AGENDA
DESIGN COMMISSION
Community Room, 3rd Floor
Arlington Heights Village Hall, 33 S. Arlington Heights Rd.
Arlington Heights, IL 60005
December 10, 2024
6:30 PM

MINUTES OF THE VILLAGE OF ARLINGTON HEIGHTS DESIGN COMMISSION

ARLINGTON HEIGHTS MUNICIPAL BUILDING
33 S. ARLINGTON HEIGHTS RD.
NOVEMBER 12, 2024

NORTH AND SOUTH
BUILDING ELEVATIONS

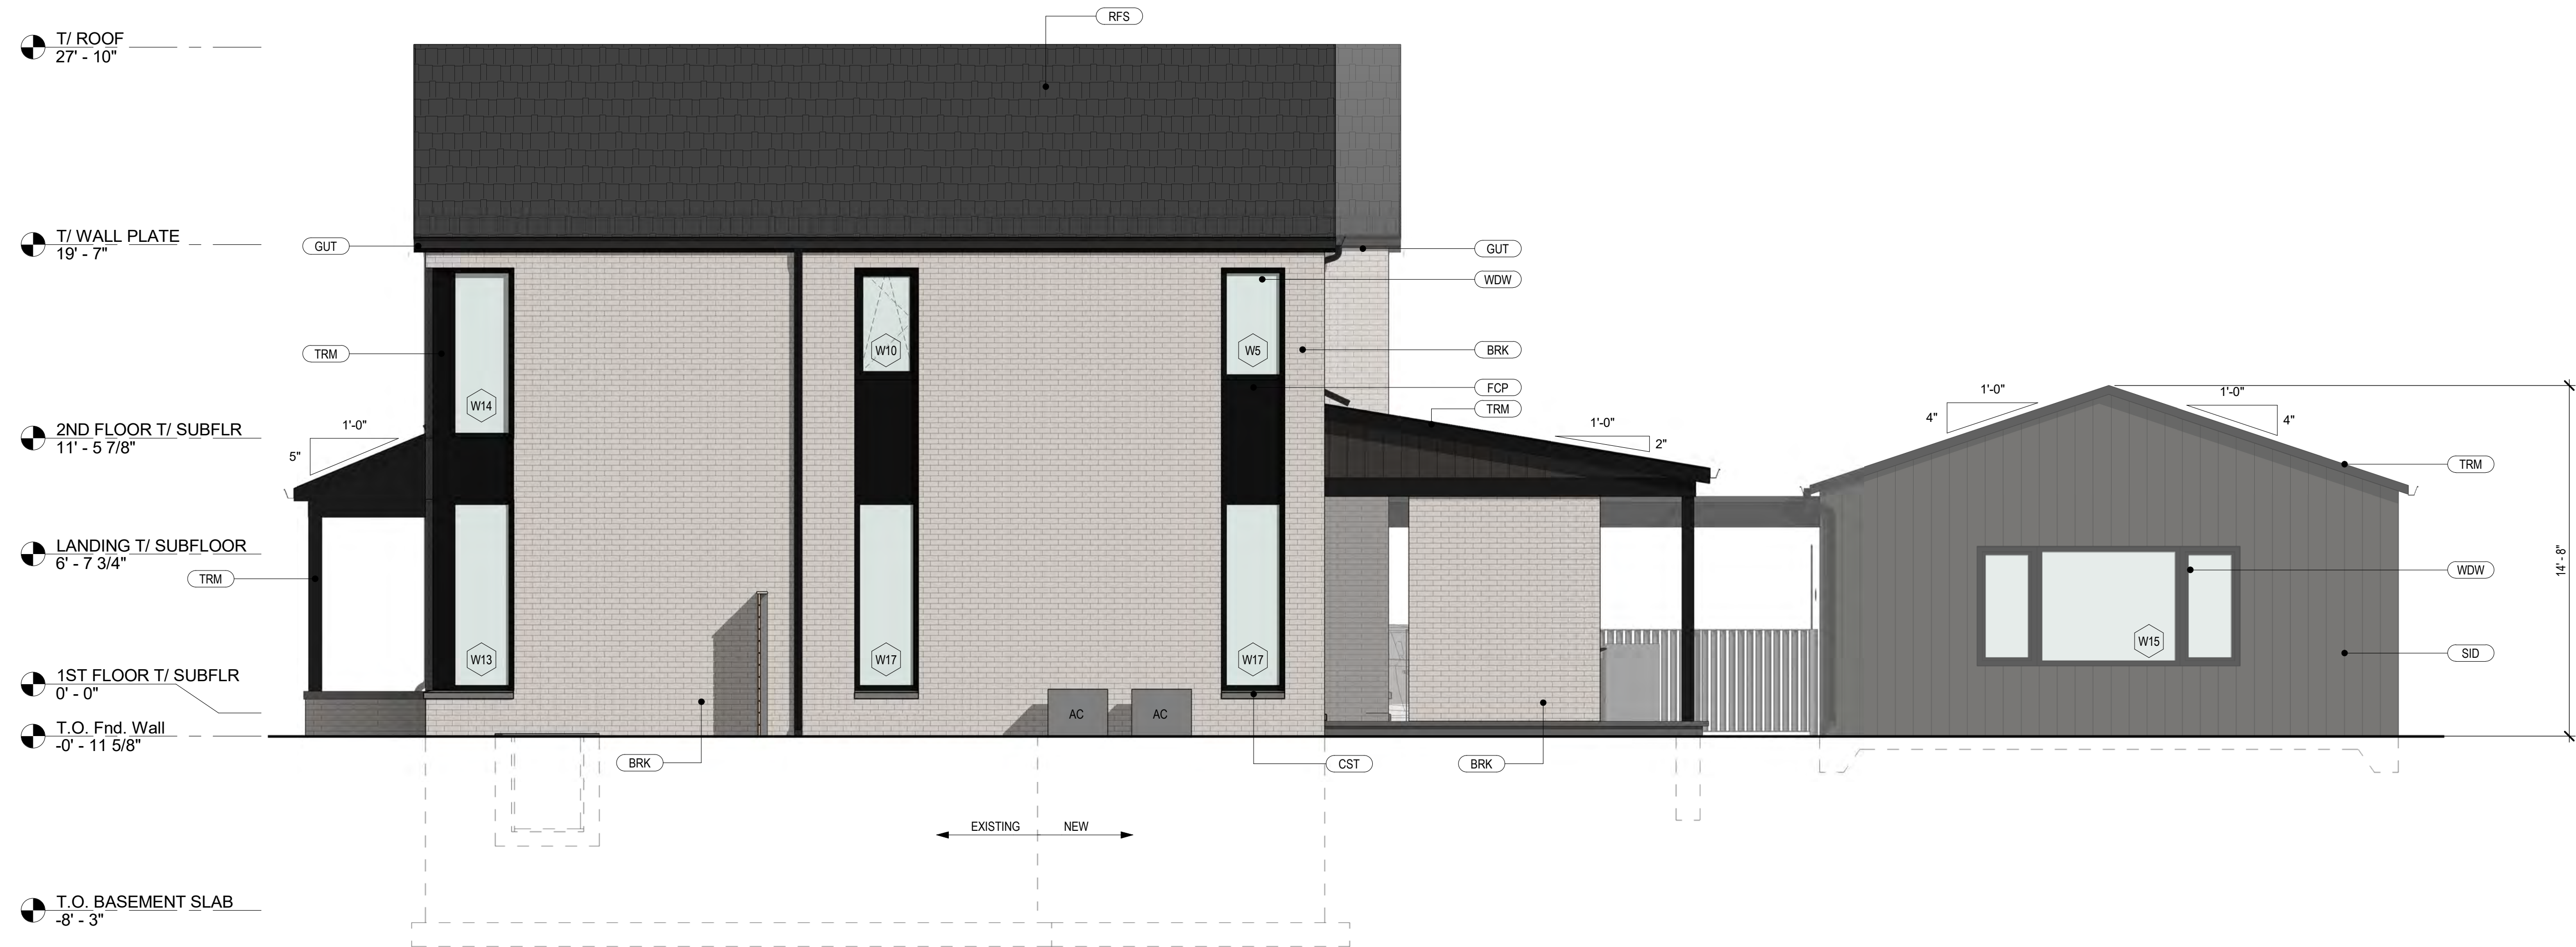
It is recommended that the Design Commission evaluate the design of the proposed new (teardown) single-family residence at 1021 N. Stratford Road. This recommendation is subject to compliance with the architectural plans received on 4/17/23, and the following:

1. Evaluate the proposed modern aesthetic against the surrounding context.
2. A recommendation to revise the asymmetrical brick on the left side of the front elevation to be a full brick gable.
3. This review deals with architectural design only and should not be construed to be an approval of, or to have any other impact on, any other zoning and/or land use issues or decisions that stem from zoning, building, signage or any other reviews. In addition to the normal technical review, permit drawings will be reviewed for consistency with Design Commission and any other Commission or Board approval conditions. It is the petitioner's responsibility to comply with the Design Commission approval and ensure that building permit plans comply with all zoning code, building permit, and signage requirements.
4. Compliance with all Federal, State, and Village codes, regulations and policies.
